**UNITED STATES  
NUCLEAR REGULATORY COMMISSION**  
WASHINGTON, D.C. 20555-0001

**SUBJECT: INDIAN POINT NUCLEAR GENERATING UNIT NOS. 2 AND 3 – NRC  
RESPONSE TO REQUEST FOR DEFERRAL OF ACTIONS RELATED TO  
BEYOND-DESIGN-BASIS SEISMIC AND FLOODING HAZARD  
REEVALUATIONS**

Evaluation of Entergy's Seismic Deferral Request for  
Indian Point Nuclear Generating Unit Nos. 2 and 3

## **Evaluation of Entergy's Flooding Deferral Request for Indian Point Nuclear Generating Unit Nos. 2 and 3**

Figure 1 – Indian Point Site Topography and Layout (Adapted from Figure 2.1-2 of December 9, 2014, Entergy Supplemental Response (ADAMS Accession No. ML14357A052))

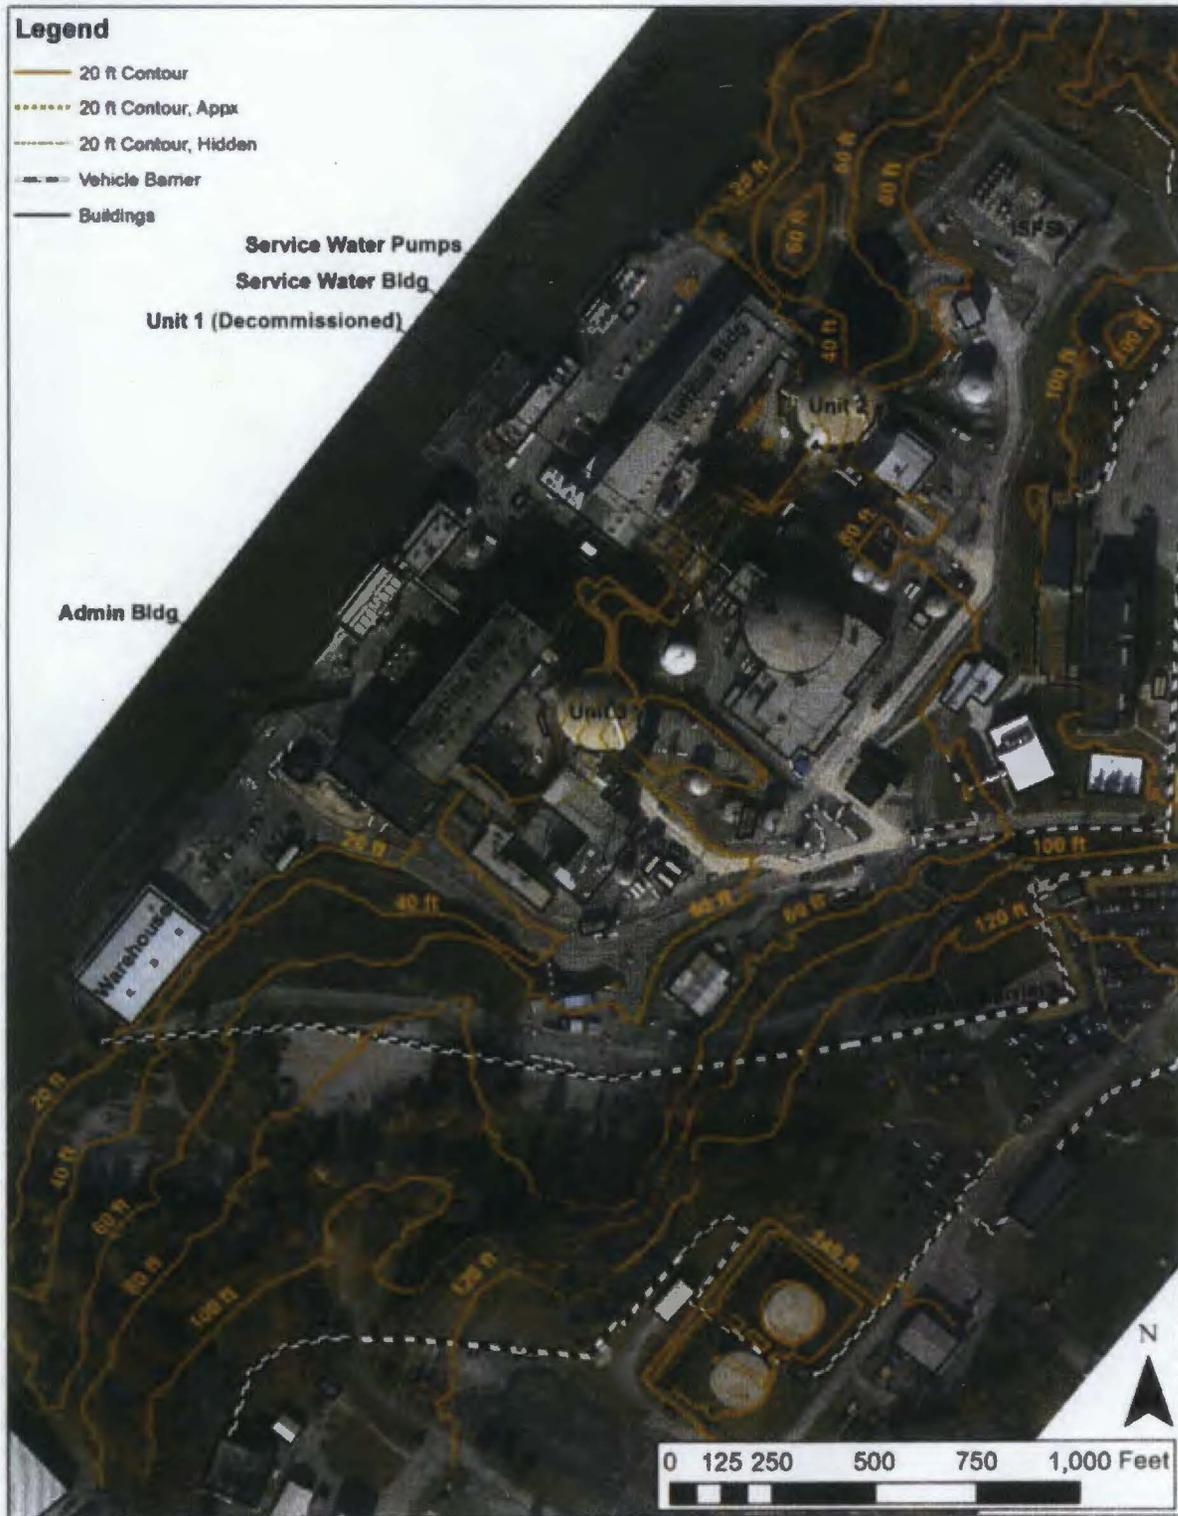
Figure 1 shows the Indian Point site layout and topography. As stated in Entergy's July 24, 2017, letter, consequential impact to the IP2 and IP3 safety-related service water pumps occurs at 17.9 feet (ft.) National Geodetic Vertical Datum of 1929 (NGVD29). Because the storm surge combined event leads to water levels above 17.9 ft. NGVD29 at the location of the service water pumps, the licensee is expected to submit an IA by December 2018. The licensee's July 24, 2017, letter states that for the other three flood hazard mechanisms (LIP, dam failure, and streams and rivers) a Path 2 FE demonstrating effective flood protection for these mechanisms would be included with the IA for the combined storm surge event.
